Report to Planning and Environment Committee

Subject: Public Participation Meeting Report
Sunningdale Golf and Country Ltd.
600 Sunningdale Road West

Public Participation Meeting on: November 12, 2018

Figure 1: Proposed Master Development Plan

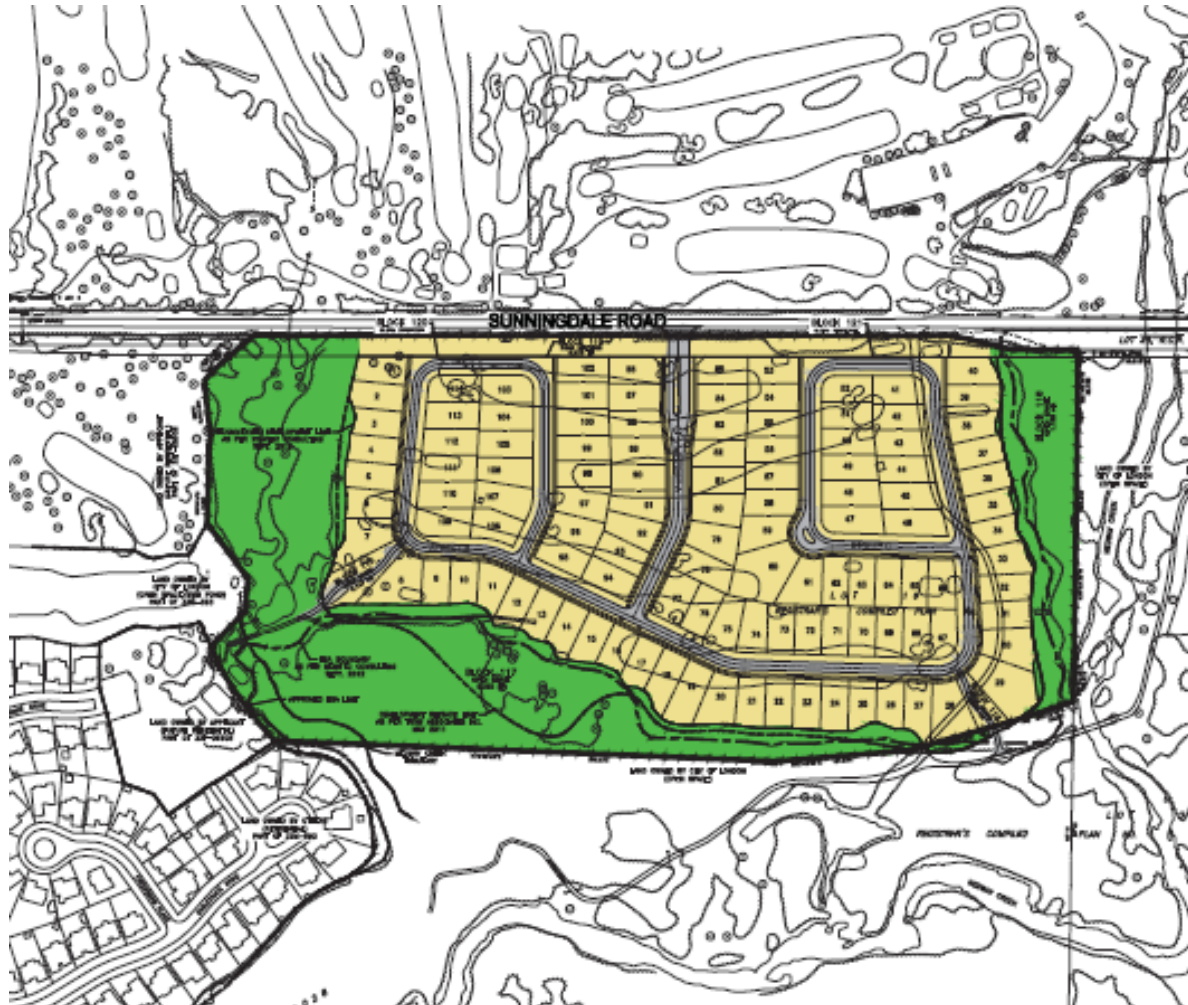
Please note the City does not support gateway islands; therefore, please remove the gateway island on Street 'A' at Sunningdale Road from the face of the plan. Since the City does not support gateway islands, Street 'A' road width may be revised to be 21.5 metres wide tapered to 20.0 metres. See condition ac).

- i) red line this plan to include 6.0m straight tangents at the intersection of Street "C" & Street "B" opposite lots 33 & 34 to the satisfaction of the City Engineer
- ii) red line this plan to include a 6.0m straight tangent between the two horizontal curves on Street "C" opposite lots 39 & 38 to the satisfaction of the City Engineer
- iii) red line this plan to provide a second access to the site to allow for emergency services access, the access is to be restricted to right in / right out through the construction of a centre island median to the satisfaction of the City Engineer – **MAY BE REVISED BASED ON REVIEW OF SUBDIVISION DESIGN**
- iv) Revise to separate road widening block, Block 119, into two parts east and west of Street 'A'
- v) Clearly delineate block/lot limits
- vi) Remove 'eyebrow' island on Street 'C'

- vii) Remove gateway island from Street 'A' as this City does not support gateway islands
- viii) Revise Street 'A' at Sunningdale Road West to be a minimum right of way width of 21.5 metres for a minimum length of 30.0 metres tapered back over a distance of 30 metres to the standard local right-of-way width of 20.0 metres, to the satisfaction of the City Engineer.
- ix) Label Street 'C', east of Street 'A'
- x) Ensure all geotechnical issues and all required (structural, maintenance and erosion) setbacks related to slope stability for lands within this plan are addressed and make any necessary revisions, to the satisfaction and specifications of the City.
- xi) The Owner shall ensure all streets with bends of approximately 90 degrees shall have a minimum inside street line radius with the following standard:
